## Product Change Notice (PCN)

**PCN Number:** PCN-0450216R-01

**Product(s) Affected:** MD-SV series (part numbers MD-30SV, MD-40SV, MD-50SV, MD-60SV, MD-70SV, MD-80SV).

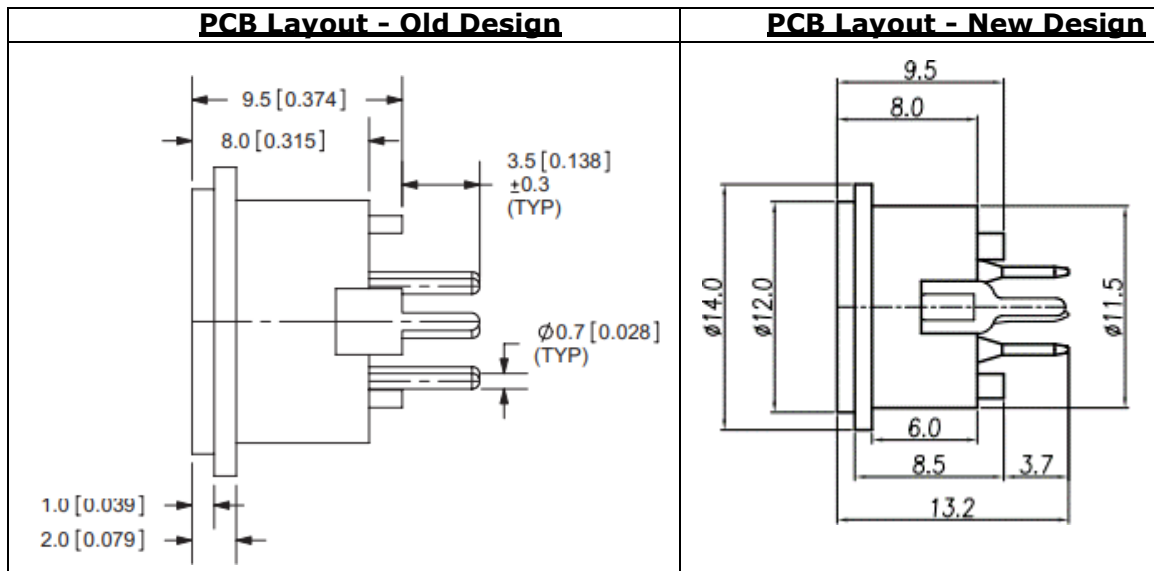
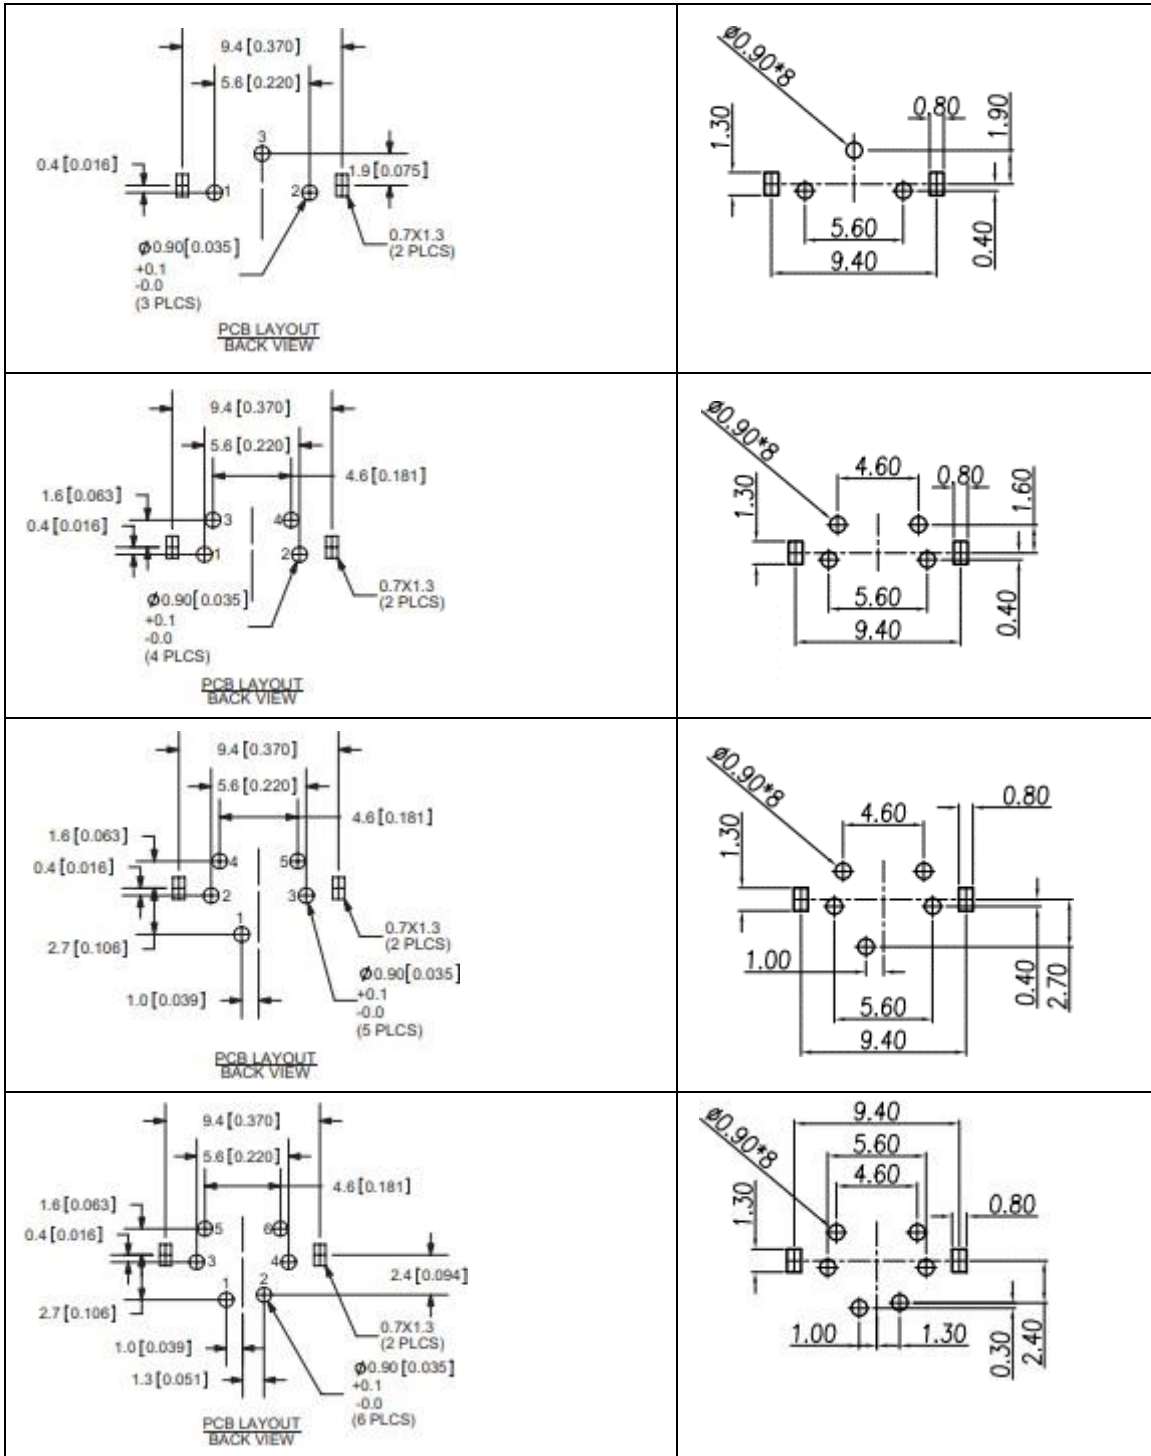
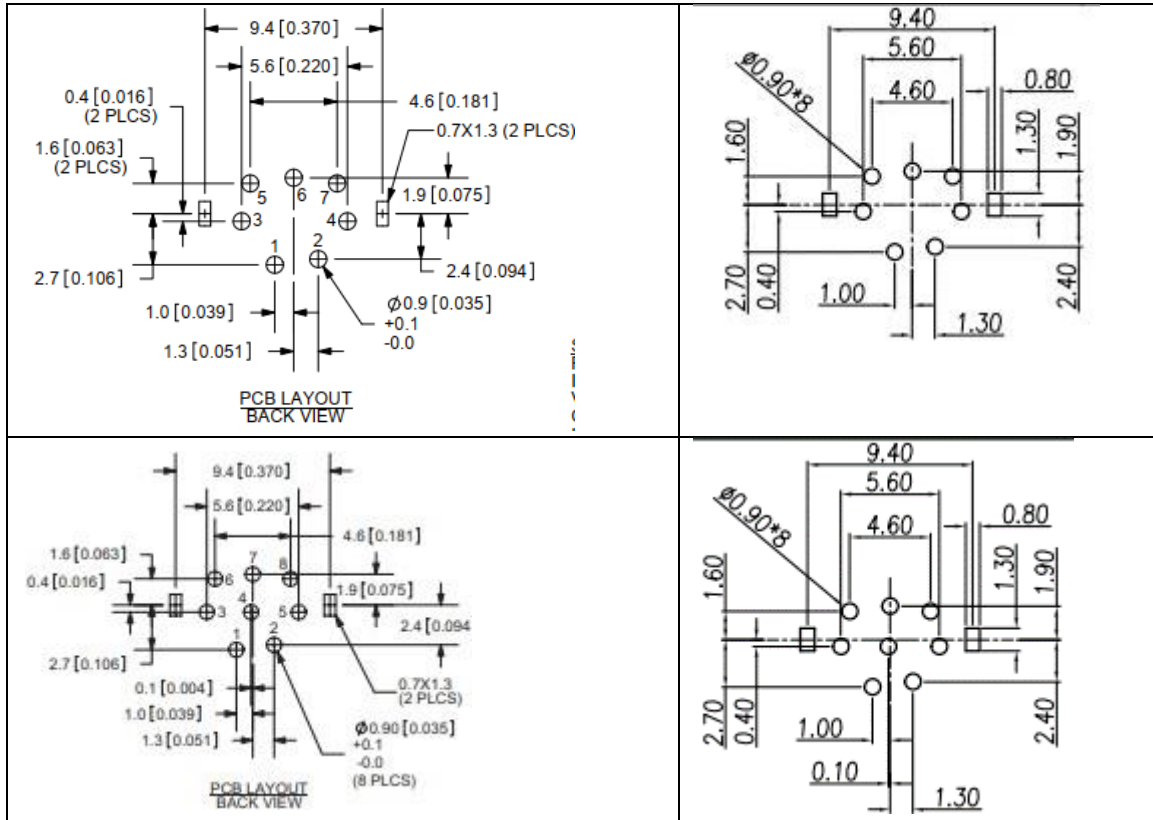
**Reason(s) for Change:** Manufacturing build location change.

**Description of Change:** minor dimensional changes, such as pin length, and materials changes as shown below.

### Old design materials

MATERIAL	PLATING
earth terminal	brass	tin
contact terminals (1~8)	phosphor bronze	silver
plastic	PBT

### New design materials

MATERIAL	PLATING/COLOR
housing	PBT (UL94V-0)	black
contacts	phosphor bronze	tin
shell	brass	nickel
